## ASSESSMENT REPORT

### MOORE THEOLOGICAL COLLEGE, NEWTOWN MP09\_0007 MOD 2

**Figure 4 – South-eastern elevation (King Street)**

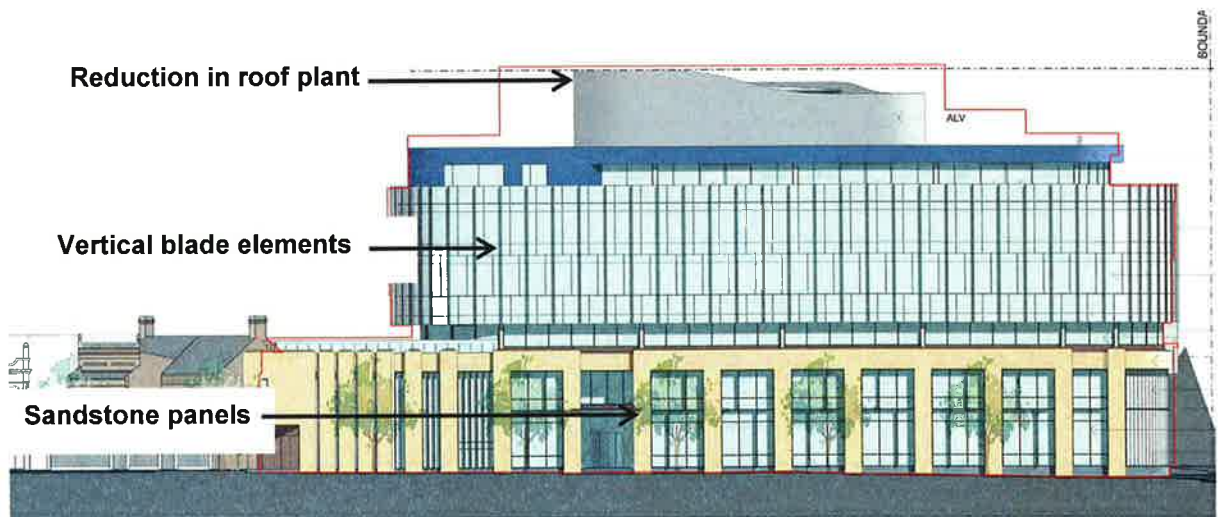
On 24 June 2015, the applicant lodged a section 75W modification application (MP09\_0007 MOD 2) seeking approval to make detailed design changes to the approved development on the basis it would improve the design outcome, and provide higher quality materials. The proposed changes are outlined in **Table 1** and the external changes are illustrated in **Figures 4 to 6**.

- the rationalisation of the horizontal and vertical blades at levels 2 to 5 into a linear form;
- an additional area of glazing at levels 3 to 5 on the western façade, which replaces the approved blue metal cladding;
- replacement of the stone coloured render with:
  - sandstone panels at the base of the building along King Street;
  - concrete columns at the base of the building along Carillon Avenue; and
  - a textured concrete wall cladding from levels 2 to 5 at the western façade.

- the building as modified would remain consistent with the overall built form of the approved building;
- the proposed changes to the façade blades and glazing at the upper levels, and the introduction of the sandstone panels and concrete columns at the lower levels, would improve the design quality of the building; and
- the proposed changes would also improve sunlight access and amenity for future occupants.
